Re: **Request for Access to Records under the Freedom of Information and Protection of Privacy Act (the "Act")**

**Subject:** RE: BSCGP - South Granville Stage 1 Piling - Revision B (e-amil 3 of 3)

Document Title: Comment Resolution Sheet for South Granville Stage 1 - Traffic Signal & Street Lighting Design

SOUTH GRANVILLE STATION  
TRAFFIC CONTROL STAGE 1  
WEST BROADWAY TRAFFIC SIGNAL &  
STREET LIGHTING PLAN (1 OF 2)  
DRAWING NUMBER  
BSP-71006-SGIG-41DD-1xxx

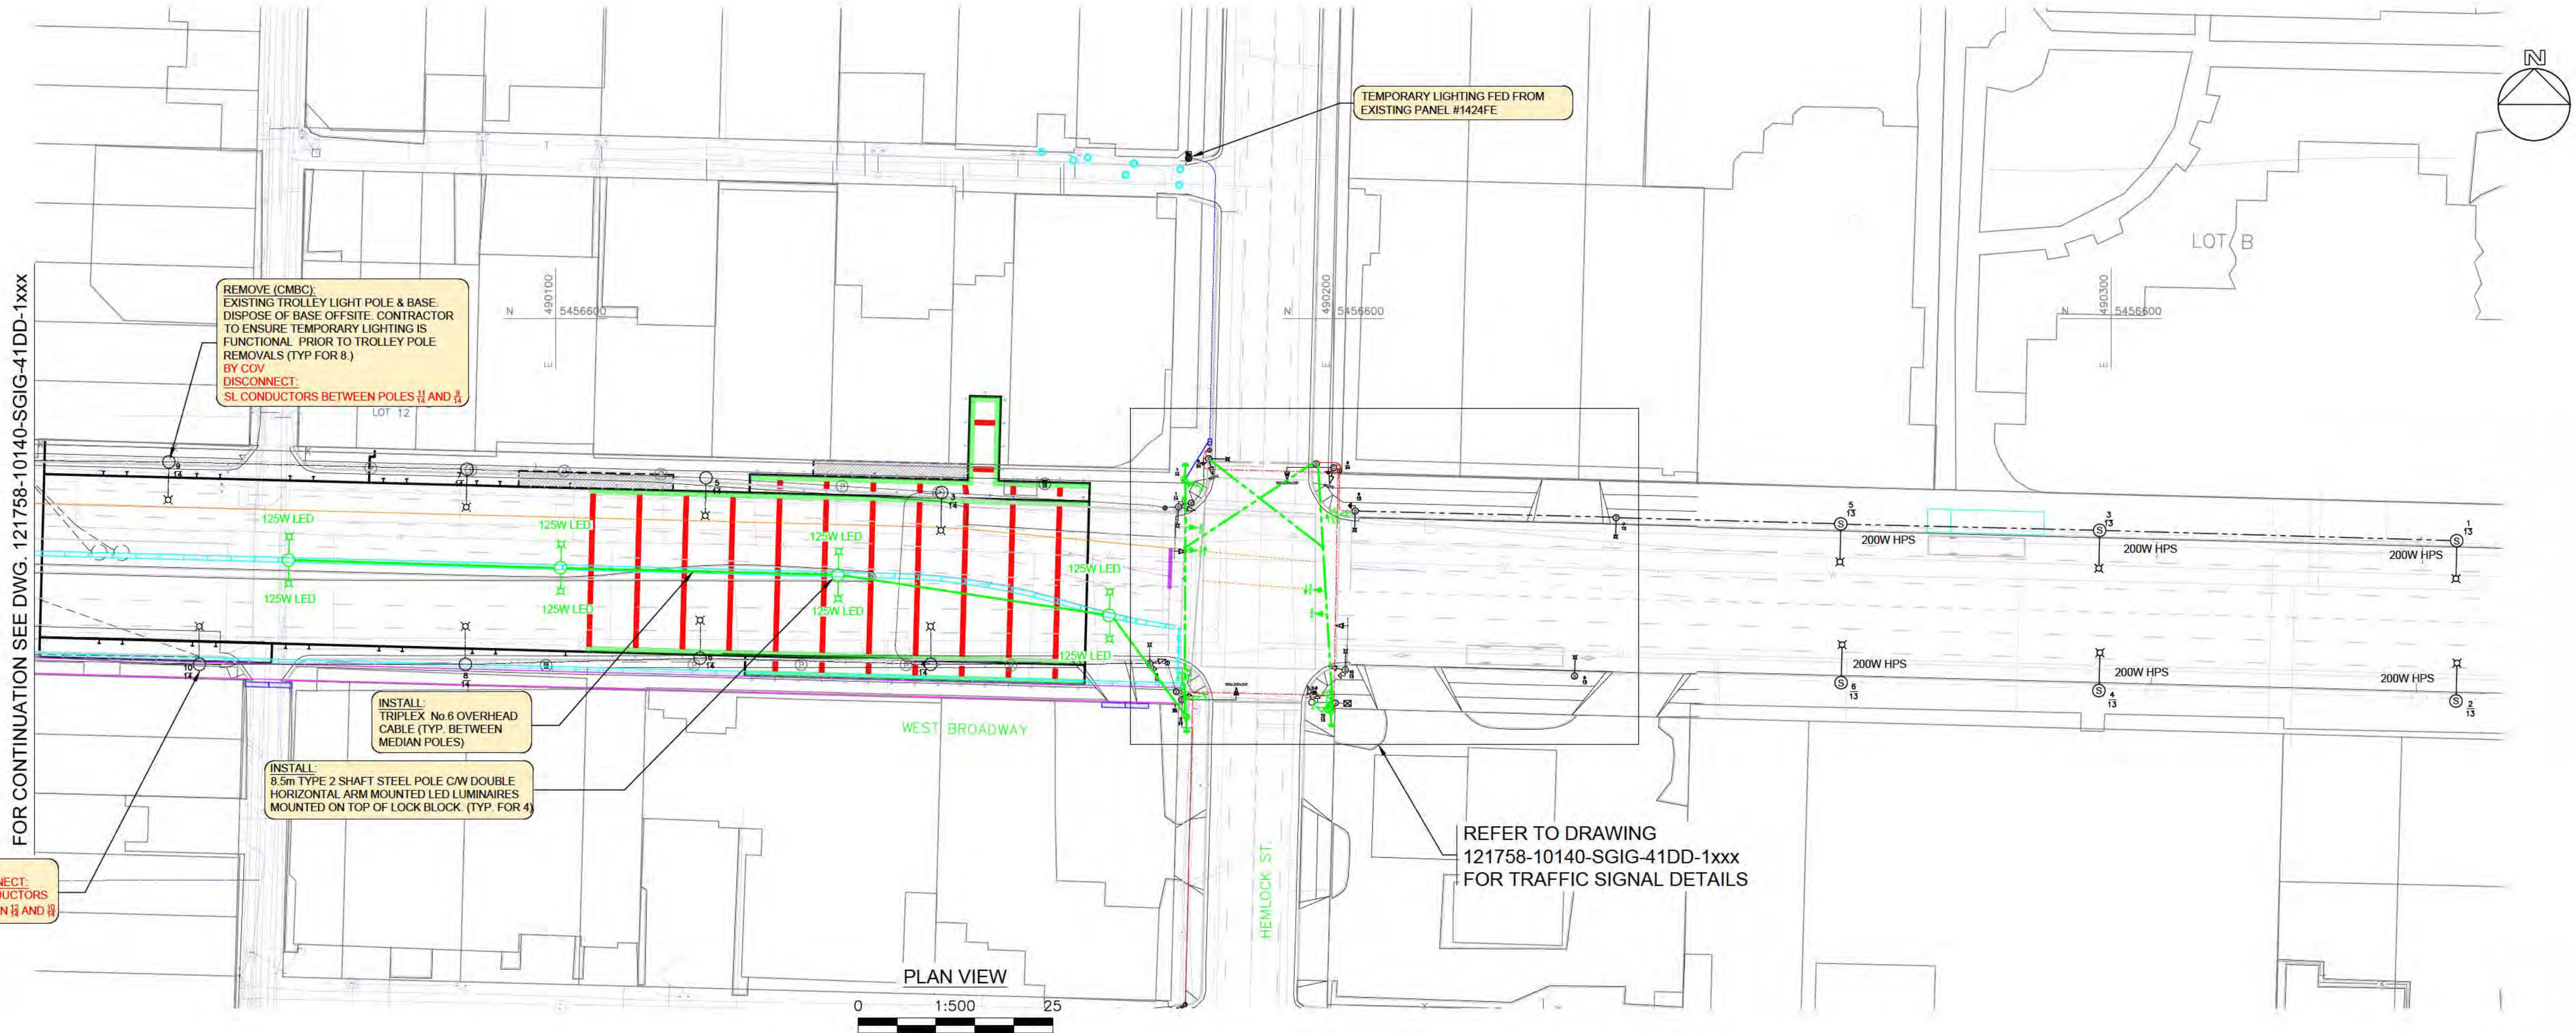
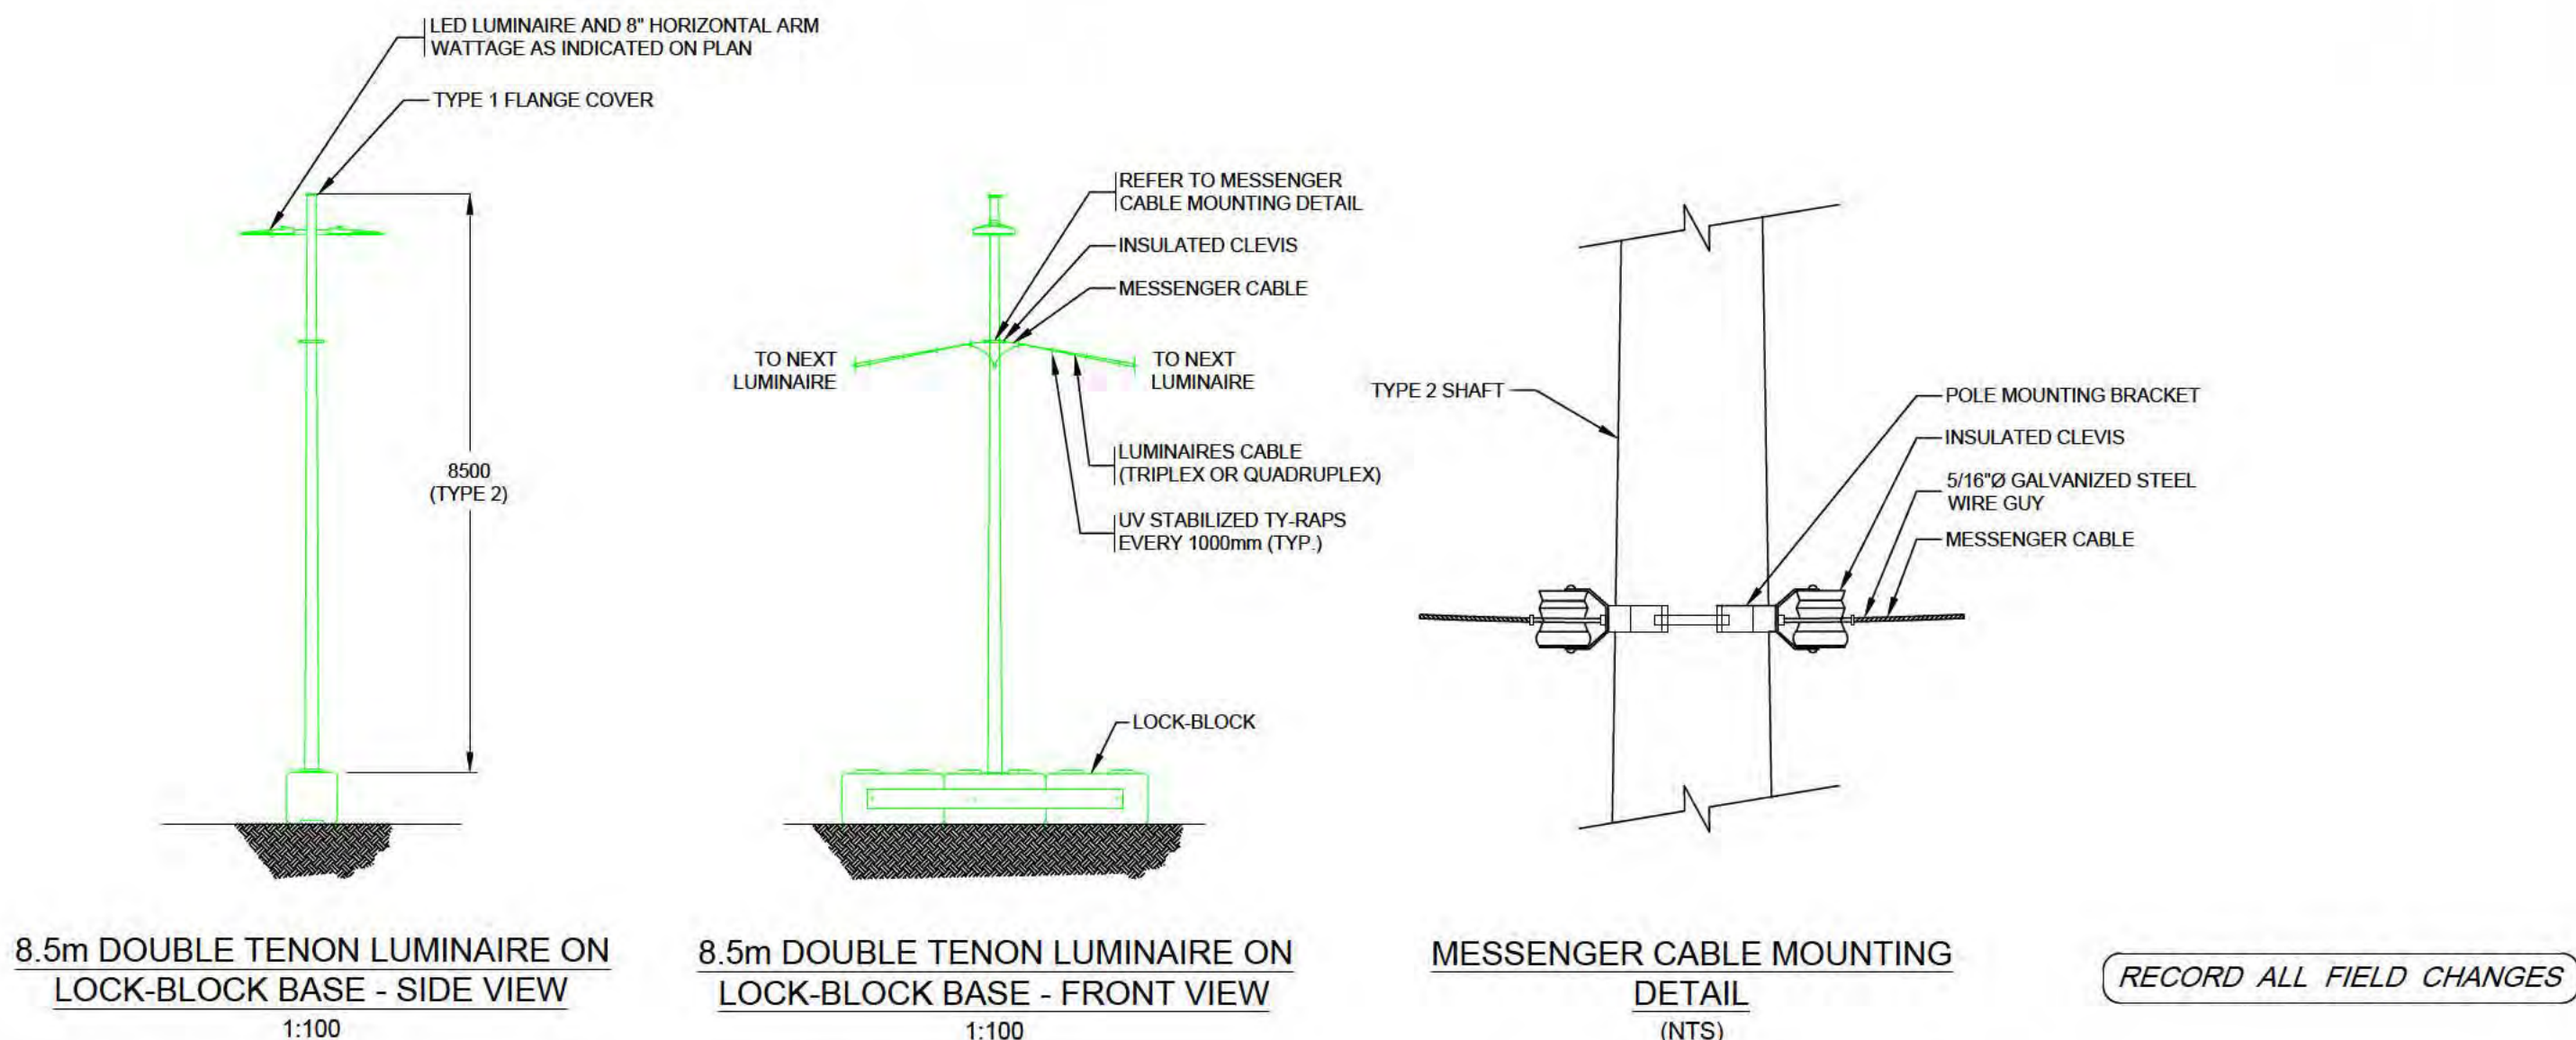
TRAFFIC SIGNAL & STREET LIGHTING DESIGN - PAGE 2		1	TEOD	No longer double davit		GNEC	Updated	Closed	
TRAFFIC SIGNAL & STREET LIGHTING DESIGN - PAGE 2		2	TEOD	SL goes through poles 1/14 and JB. Wires need to be disconnected at poly 1000 JB.		GNEC	Updated	Closed	
TRAFFIC SIGNAL & STREET LIGHTING DESIGN - PAGE 3		3	TEOD	This is not practical. New head should be installed before old is removed.		GNEC	Changed so that the existing head is removed and returned to city yard after installation of new head.	Closed	
TRAFFIC SIGNAL & STREET LIGHTING DESIGN - PAGE 3		4	TDM	as discussed, current cabinet won't allow for actuated LT phases		GNEC	noted.	Closed	
TRAFFIC SIGNAL & STREET LIGHTING DESIGN - PAGE 3		5	TEOD	Add note for ex. signal arm and heads to be removed.		GNEC	Added	Closed	
TRAFFIC SIGNAL & STREET LIGHTING DESIGN - PAGE 3		6	TDM	please shift to the north so it is not in line with the DDL		GNEC	Shifted so both heads are centered on the lanes.	Open

TRAFFIC SIGNAL & STREET LIGHTING DESIGN - PAGE 5		17	TDM	what is the ped clearance between the pole and the barrier?				Open	
TRAFFIC SIGNAL & STREET LIGHTING DESIGN - PAGE 5		18	TDM	update for the left turns (primary and secondary heads)		GNEC	Updated	Closed	
TRAFFIC SIGNAL & STREET LIGHTING DESIGN - PAGE 5		19	TEOD	If SL is in fact in the Poly 1000 JB, then SL conductors will be needed from this JB to wood pole 1/14 to feed intersection lighting and mid-block poles. Source of power is separate from signal controller power, so overbuilding with #3 JB next to existing poly JB is recommended to pick up SL.		GNEC	Added a type 3 JB to intercept existing SL and extend to new wood pole.	Closed	
TRAFFIC SIGNAL & STREET LIGHTING DESIGN - PAGE 5		20	TDM	please show utilities/water/fire hydrant as previously discussed		GNEC	Existing hydrant is shown on our drawings, it is located by pole 6/24	Open	
TRAFFIC SIGNAL & STREET LIGHTING DESIGN - PAGE 5		21	TEOD	Pole not being removed anymore, so no need to disconnect.		GNEC	updated	Closed

Confirm with CMBC if pole can handle load of span and arm.

no response and no dimension added

is it ok to be that close?
